Project Description: Juniper Sauna Co

**Project/File:** **Juniper Sauna Co / GC25-0009 / DSRFY2025-0010**

This design review application is for a 2,650-square-foot commercial building located on 0.344 acres.

## C. Site Plan

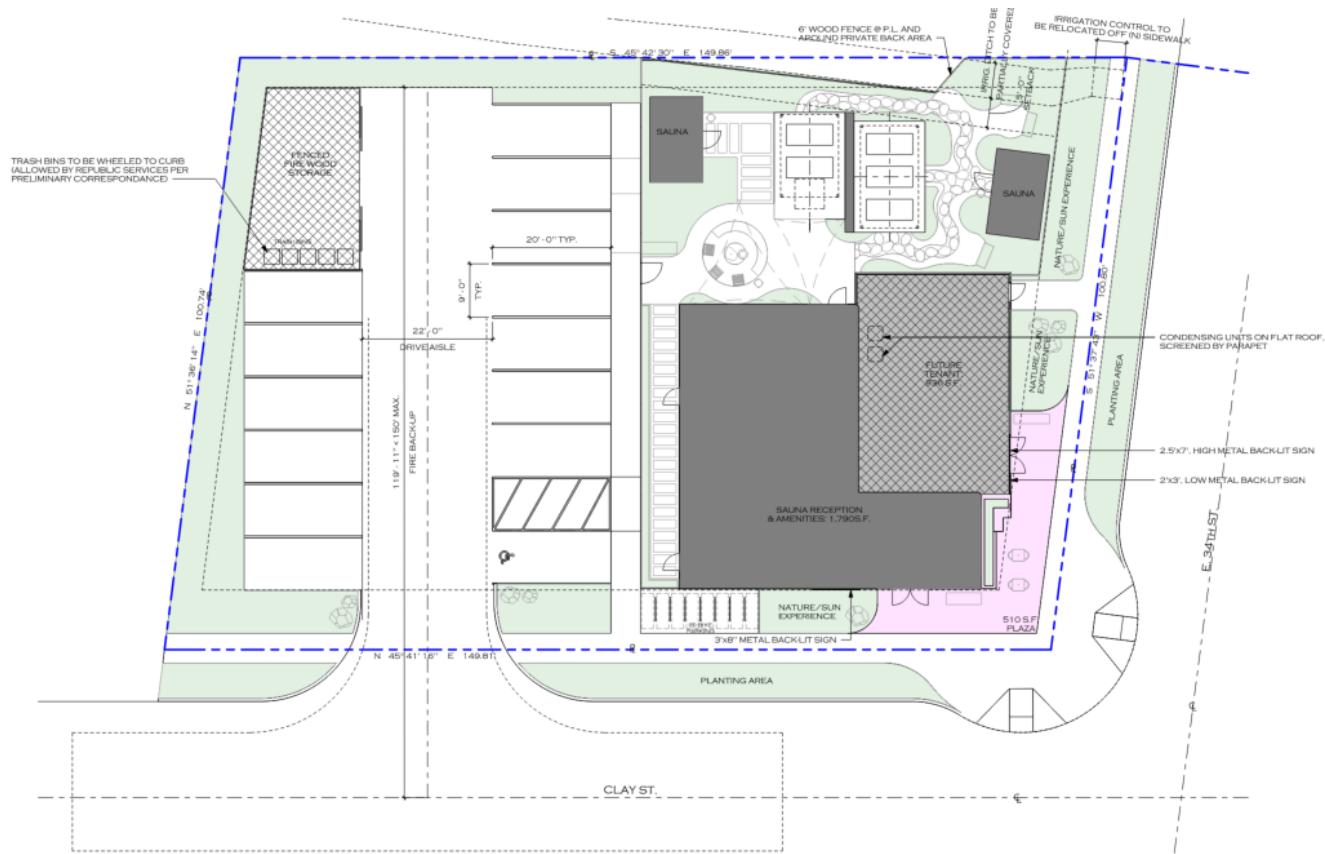
- c. Staff Comments/Recommendations:** The applicant's proposal does not meet District Policy and should not be approved, as proposed. To meet District Policy, the applicant should be required to construct Clay Street abutting the site as half of a 36-foot-wide local commercial street section with vertical curb, gutter, and 5-foot-wide attached or detached concrete sidewalk. If detached sidewalk and street trees are desired, then an 8-foot-wide landscape barrier should be provided.

The applicant should be required to dedicate right-of-way on Clay Street extending to 2-feet behind the back of sidewalk. For detached sidewalks, the applicant may dedicate right-of-way to extend 2-feet behind the back of curb and provide a permanent right-of-way easement from the edge of right-of-way to 2-feet behind the back of sidewalk. Sidewalk should be located entirely within the right-of-way or entirely within the easement.

The applicant's proposal to construct a bulb-out at the northwest corner quadrant of the Clay Street and 34<sup>th</sup> Street intersection aligns with ACHD's future plans for the area and should be approved, as proposed. The applicant will be required to provide a minimum of 24-feet of pavement between the bulb-outs at the intersection, as measured from face of curb to face of curb.

The applicant should be required to provide written fire department approval for use the bulb-out.

- c. Staff Comments/Recommendations:** The applicant's proposal does not meet District Policy and should not be approved as proposed. To meet District Policy, the applicant should be required to construct 34<sup>th</sup> Street abutting the site as half of a 36-foot-wide local commercial street section with vertical curb, gutter, and 5-foot-wide concrete sidewalk. If detached sidewalk and street trees are desired, then a minimum 8-foot-wide landscape barrier should be provided.

The applicant should be required to dedicate right of way on 34<sup>th</sup> Street extending to 2-feet behind the back of sidewalk. For detached sidewalks, the applicant may dedicate right-of-way to extend 2-feet behind the back of curb and provide a right-of-way easement from the edge of right-of-way to 2-feet behind the back of sidewalk. Sidewalk should be located entirely within the right-of-way or entirely within the easement.

- a. Existing Conditions:** There are no existing driveways from the site onto Clay Street.
- b. Applicant's Proposal:** The applicant is proposing to construct a 20-foot-wide, paved driveway from the site onto Clay Street located 45-feet east of the site's west property line.
- c. Staff Comments/Recommendations:** The applicant's proposal meets District Policy and should be approved, as proposed.

1. Construct Clay Street abutting the site as half of a 36-foot-wide local commercial street section with vertical curb, gutter, and 5-foot-wide concrete sidewalk. If detached sidewalk and street trees are required by Garden City, then an 8-foot-wide landscape barrier shall be provided

2. Construct 34<sup>th</sup> Street abutting the site as half of a 36-foot-wide local commercial street section with vertical curb, gutter, and 5-foot-wide concrete sidewalk. If detached sidewalk and street trees are required by Garden City, then a minimum 8-foot-wide landscape barrier shall be provided.

3. Construct a bulb-out at the northwest corner of the intersection of Clay Street and 34<sup>th</sup> Street. Design the bulb-out to provide a minimum of 24-feet of pavement between the bulb-outs at the intersection, as measured from face of curb to face of curb. Provide written fire department approval of use the bulb-out.

4. Dedicate right of way on Clay Street and 34<sup>th</sup> Street extending to 2-feet behind the back of sidewalk. For detached sidewalks, the applicant may dedicate right-of-way to extend 2-feet behind the back of curb and provide a right-of-way easement from the edge of right-of-way to 2-feet behind the back of sidewalk. Sidewalk should be located entirely within the right-of-way or entirely within the easement.

5. Construct a 20-foot-wide, paved driveway from the site onto Clay Street located 45-feet east of the site's west property line.
6. Submit civil plans to ACHD Development Services for review and approval. The impact fee assessment will not be released until the civil plans are approved by ACHD.
